# 7ELEVEN AT WALLBROOK (LOT 11)

## SITE DEVELOPMENT PLAN

**7ELEVEN AT WALLBROOK (LOT 11)**  
Town of Rolesville Project No. SDP 23-\_\_\_\_  
US 401 Business / S. Main Street & Virginia Water Drive  
Wake Forest Township, Town of Rolesville, Wake County, North Carolina

**Final Drawing - Issued for Permit Review Purposes Only**

**EROSION CONTROL PLAN - PH. 2**  
**7ELEVEN AT WALLBROOK (LOT 11)**  
 Town of Rolesville Project No. SDP 23-\_\_\_\_  
 US 401 Business / S. Main Street & Virginia Water Drive  
 Wake Forest Township, Town of Rolesville, Wake County, North Carolina

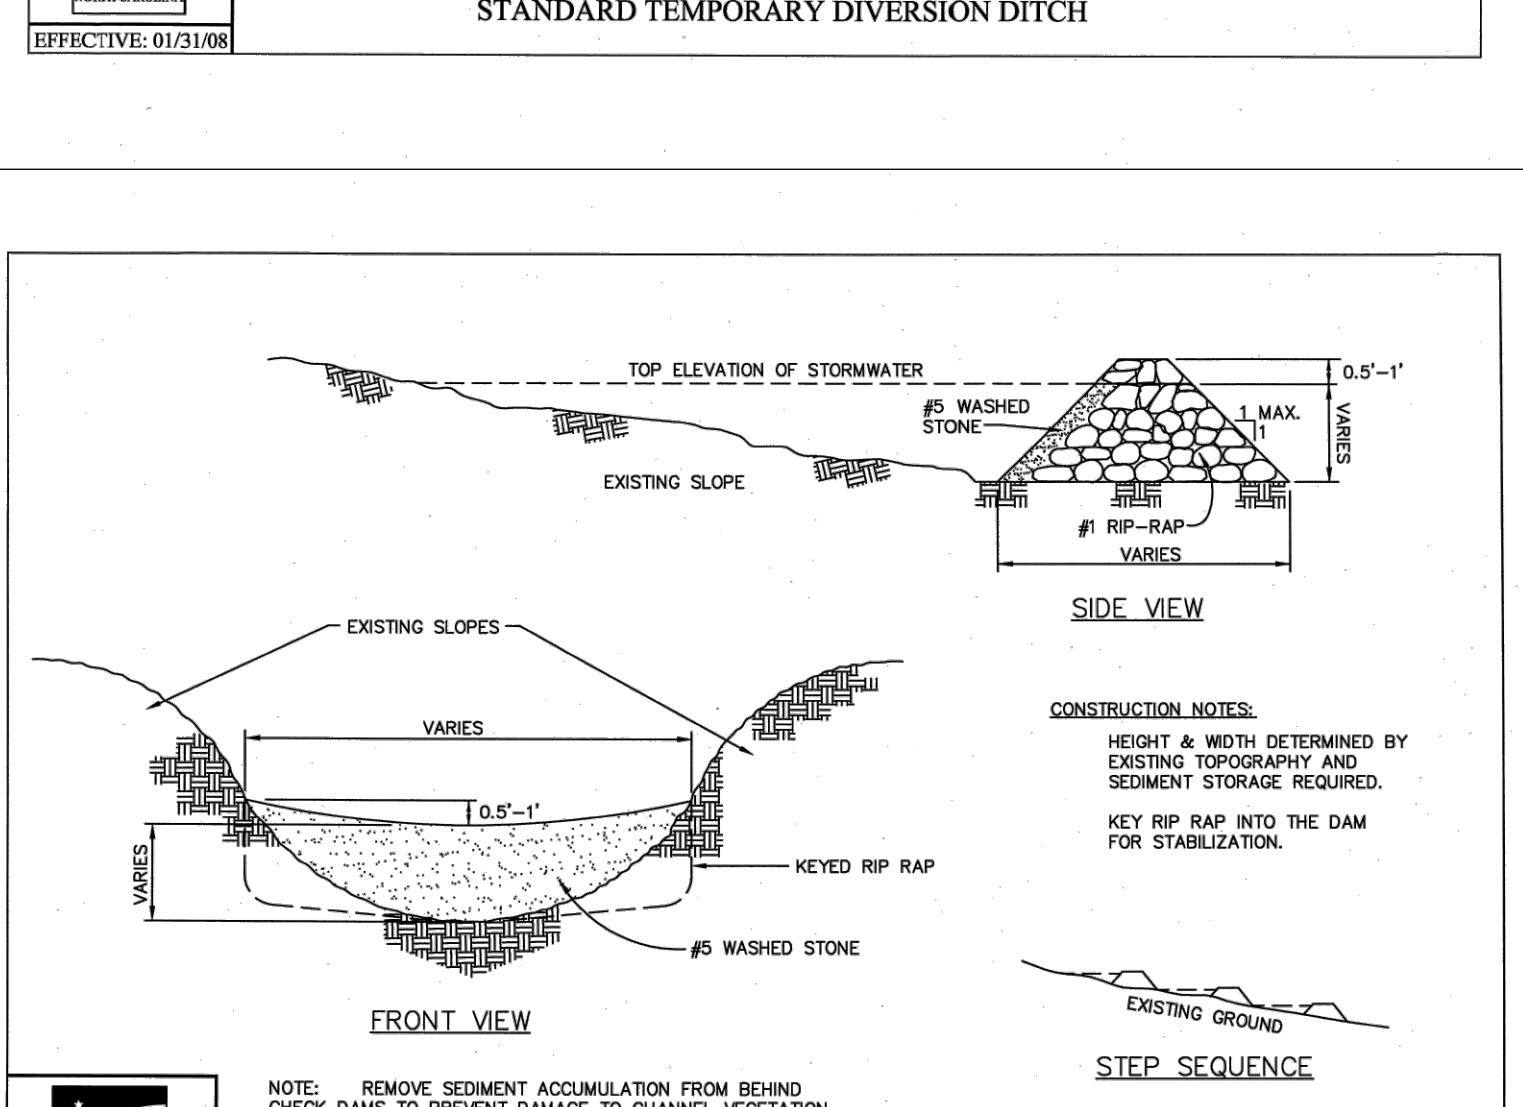
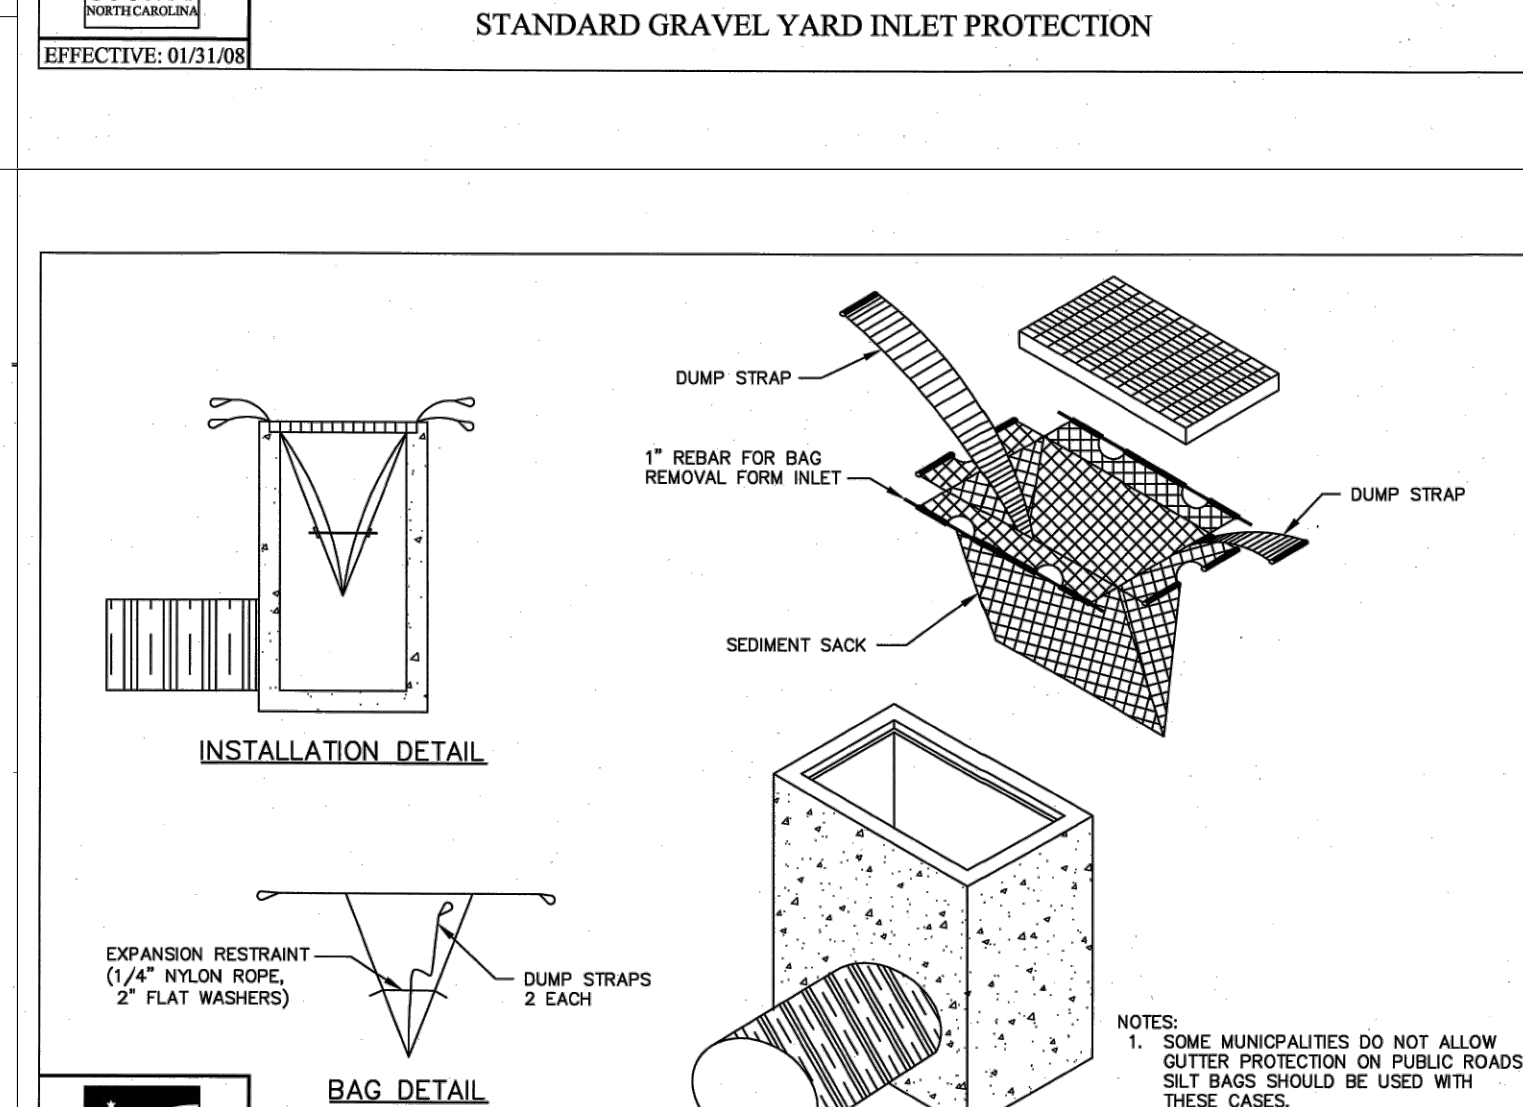
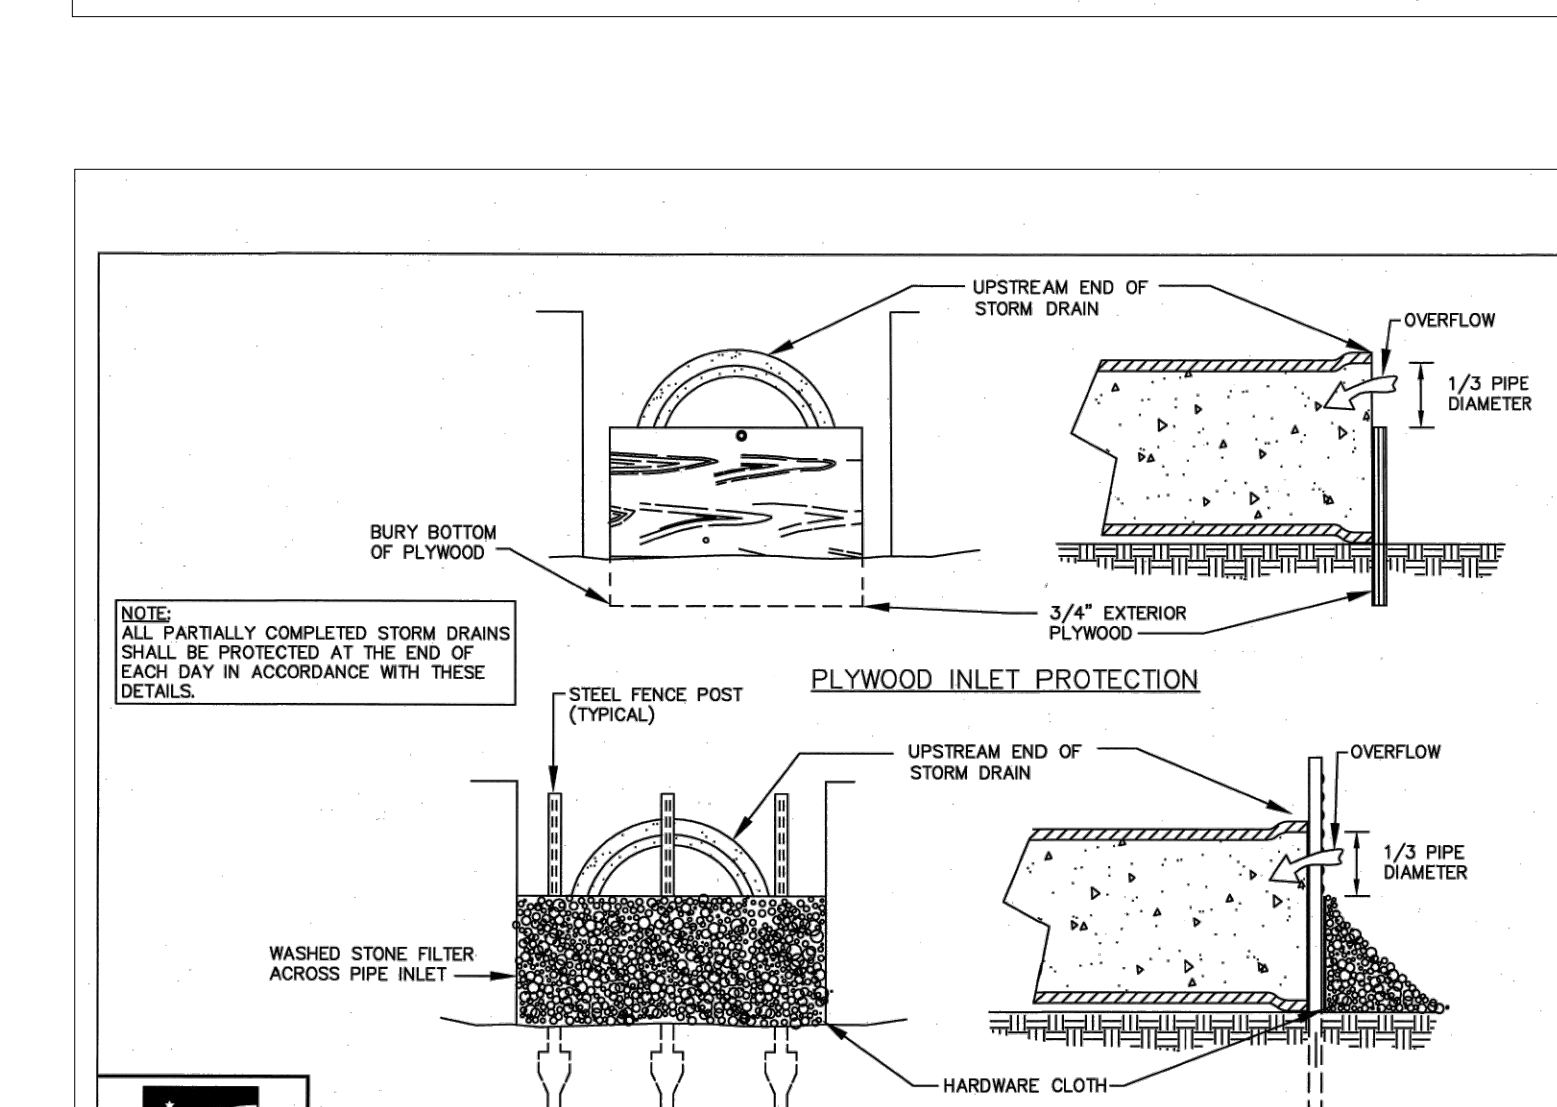
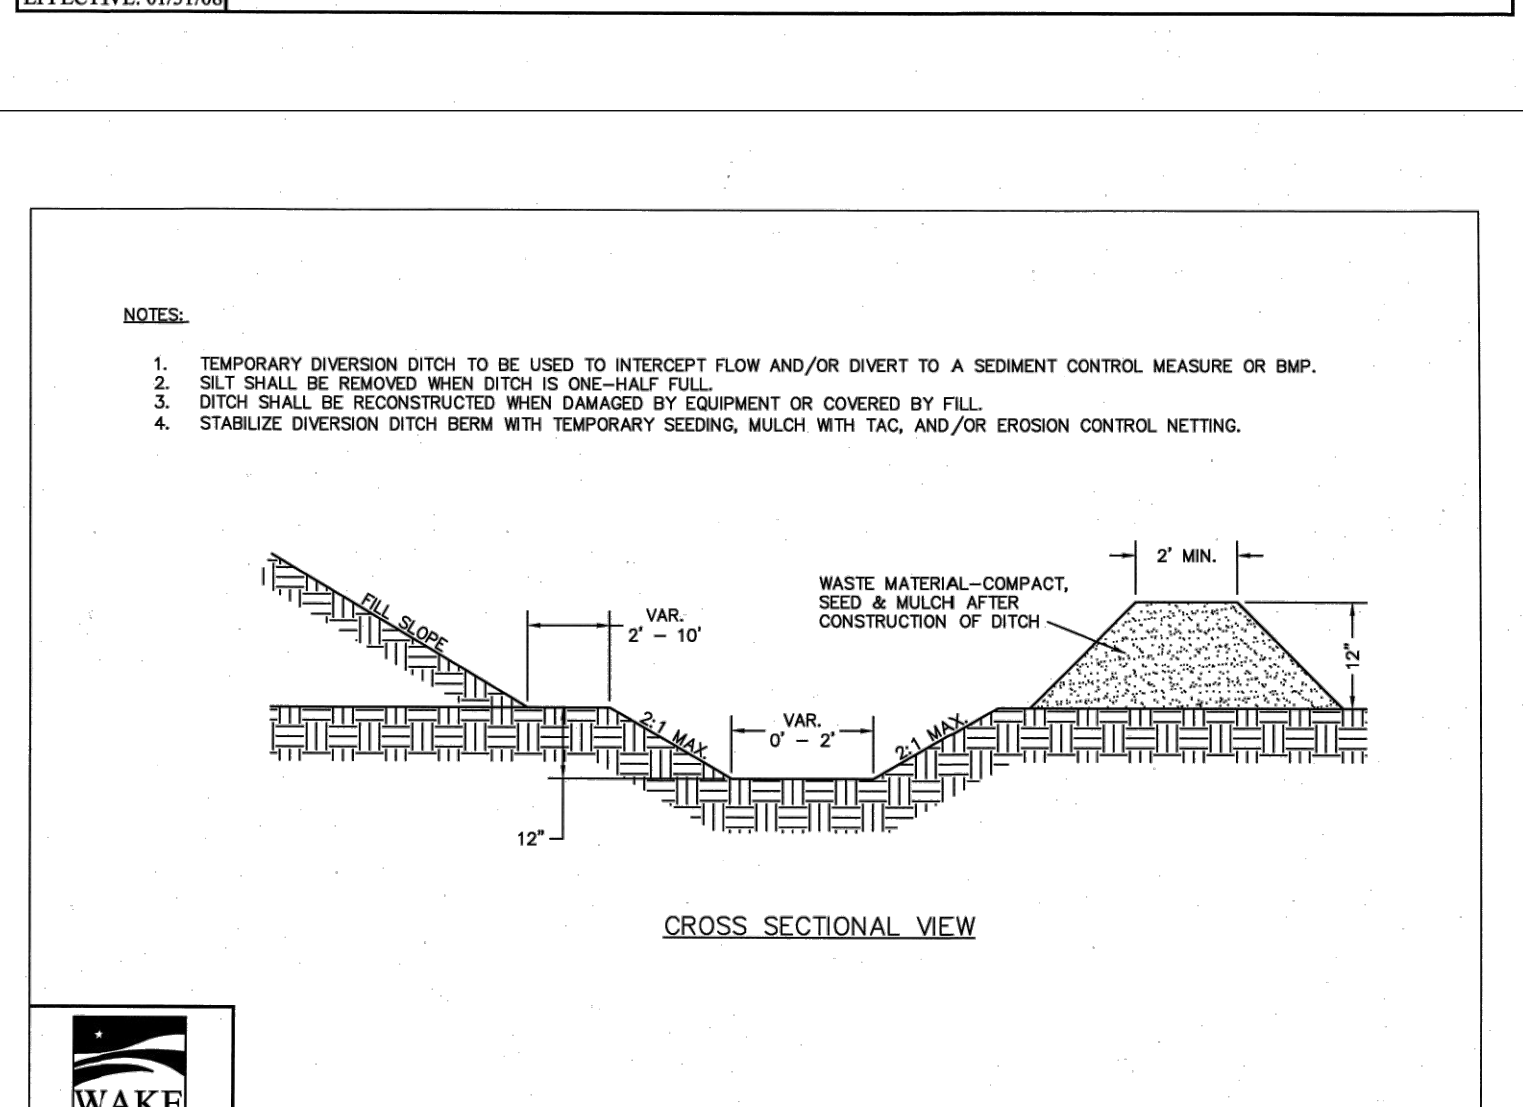
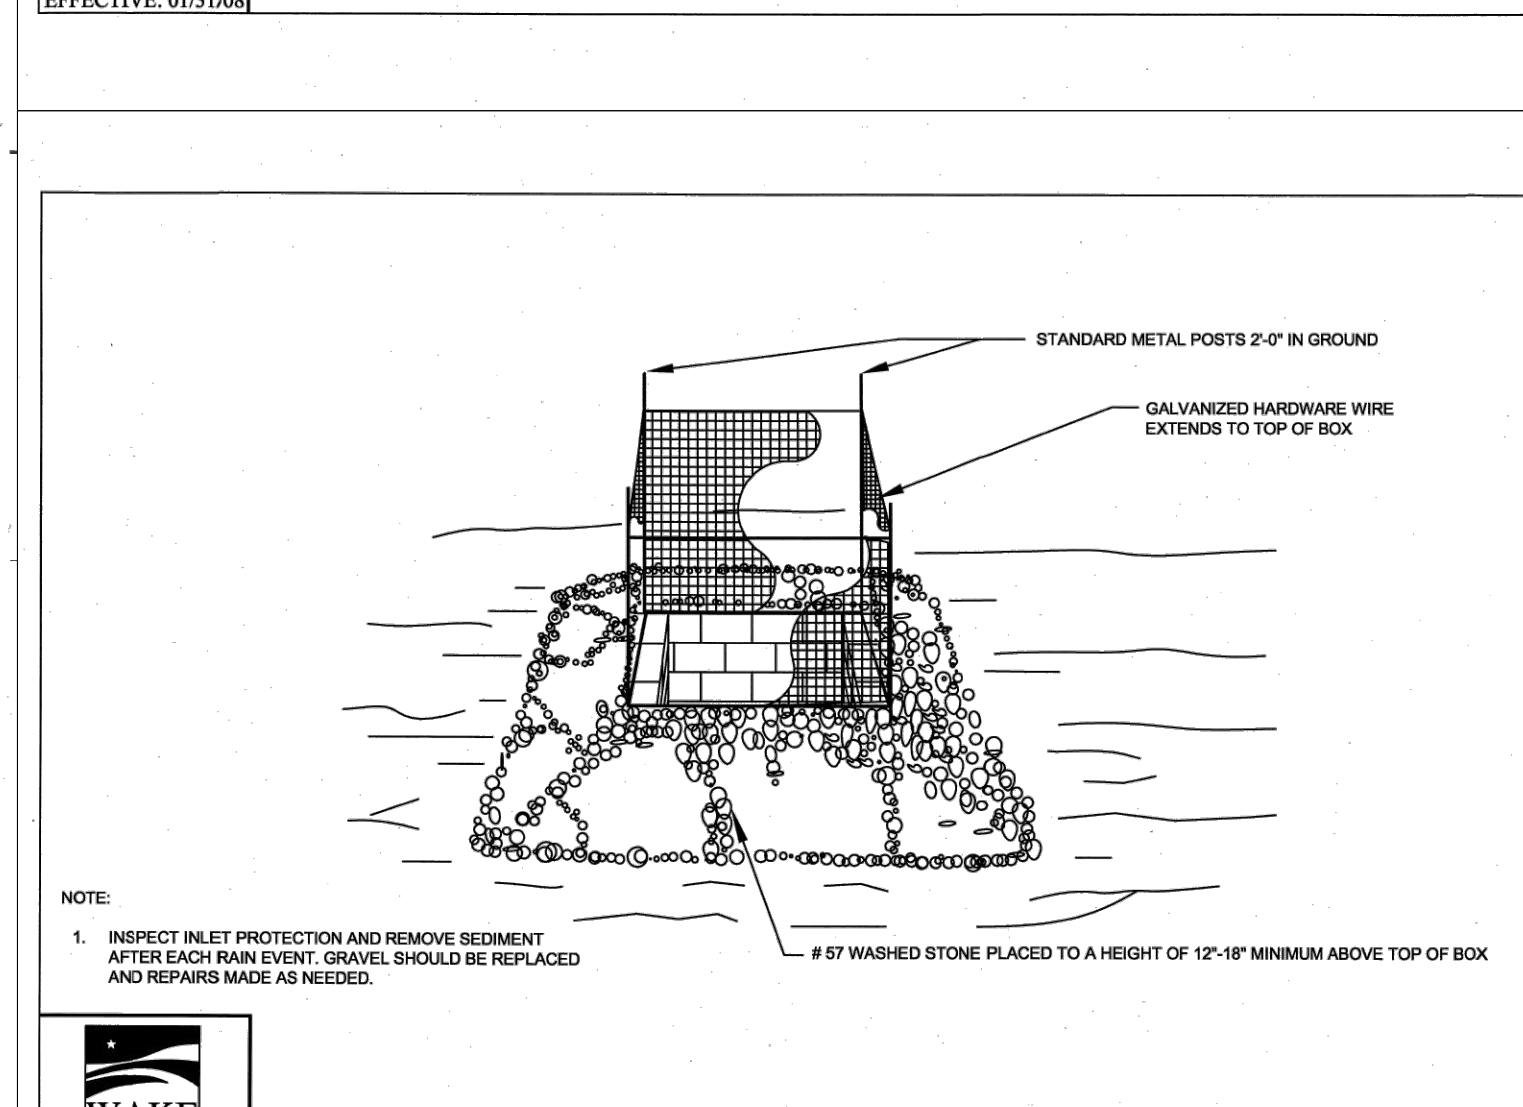
Clarify which CID this is referring to.

Label tree protection fencing and critical root zone of any trees to be preserved.
